**PLANNED UNIT DEVELOPMENT &  
SUBDIVISION STAFF REPORT**

**Date: May 6, 2004**

**DEVELOPMENT NAME** Heron Lakes Subdivision, Phase One, Revised Lot 32

# SITE PLAN

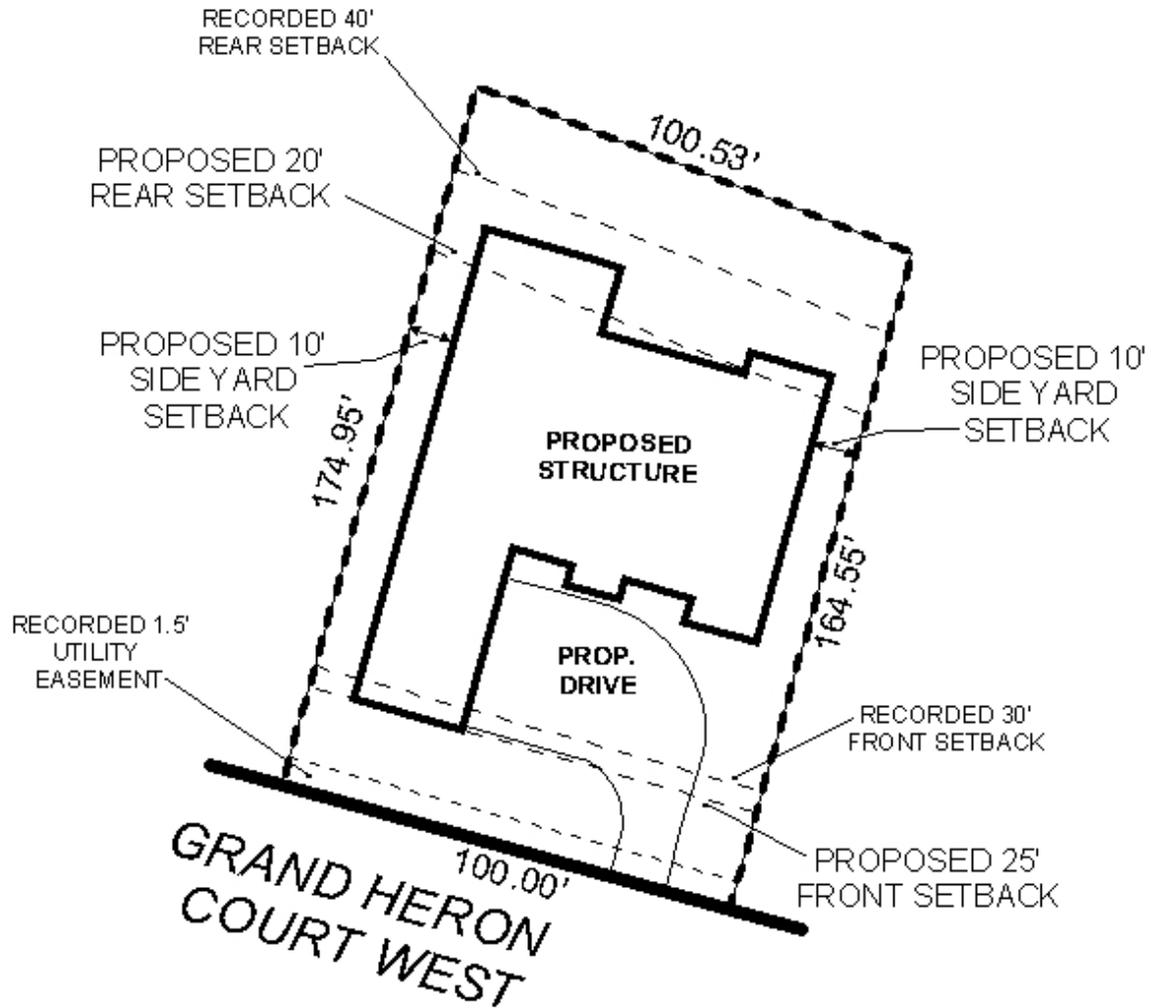
**ENGINEERING COMMENTS** Engineer to provide verification that existing stormwater system, including designed and constructed detention, can accommodate increased coverage. Must comply with all stormwater and flood control ordinances. Any work performed in the right of way will require a right of way permit.

35 percent to 40 percent and to allow reduced front and rear yard setbacks. Site coverage regulates the ratio of the property that can be developed with a structure, it does not include paved areas such as driveways and patios. Additionally, the record plat illustrates 40-foot rear yard and 30-foot front yard setbacks; the applicant proposes to reduce the front yard setback to 25-feet and the rear yard setback to 20-feet, thus Subdivision approval is also required to modify these setbacks on the record plat.

The applicant is requesting increased site coverage; the Ordinance allows up to 35 percent site coverage in a R-1, Single-Family Residential district, the applicant is requesting 40 percent. In single-family residential PUDs, and in Heron Lakes in particular, additional site coverage is frequently requested; and in this instance the request is minimal—an additional five percent. However, a typical condition is the submission of verification by an Engineer that the existing stormwater system, including designed and constructed detention, can accommodate the increased site coverage.

The proposed setback lines (25-feet along the front and 20-feet along the rear) comply with the minimum setback requirements of both the Zoning Ordinance and Subdivision Regulations and thus could be considered appropriate for the site. Furthermore, there have been numerous requests for modified front and rear yard setbacks in Heron Lakes.

**RECOMMENDATION**      **Planned Unit Development:** Based upon the preceding, this application is recommended for approval subject to the following condition: 1) that the Engineer provide verification that the existing stormwater system, including designed and constructed detention, can accommodate the increased site coverage.

**Subdivision:** The plat meets the minimum requirements of the Subdivision Regulations and is recommended for Tentative Approval subject to the following condition: 1) that the Engineer provide verification that the existing stormwater system, including designed and constructed detention, can accommodate the increased site coverage.
